Service Bulletin

Bulletin No.: 22-NA-165

Subject: Brake Squeal Noise at Low Speeds (Pursuit Rated Option)

Brand:	Model:	Model Year:		VIN:		Engine:	Transmission:
		from	to	from	to		
Chevrolet	Tahoe PPV	2021	2024

6581016

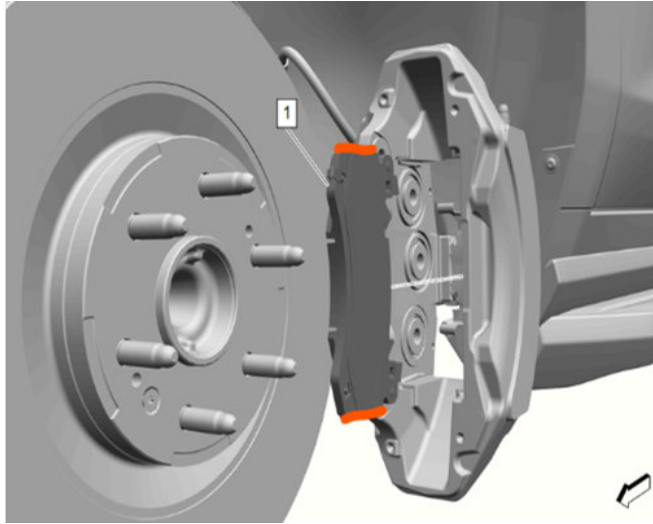
- Apply approximately 0.09-0.15 g (0.003-0.005 oz) of copper past PN# 19303310 (PN# 19303311 Canada) or equivalent on the brake pad abutments (1), as shown in the picture above, which contacts the brake caliper.

Important: DO NOT get any copper paste (grease) on the friction face, **OR** any of the rubber components of the caliper, **OR** on the back of the brake pad.
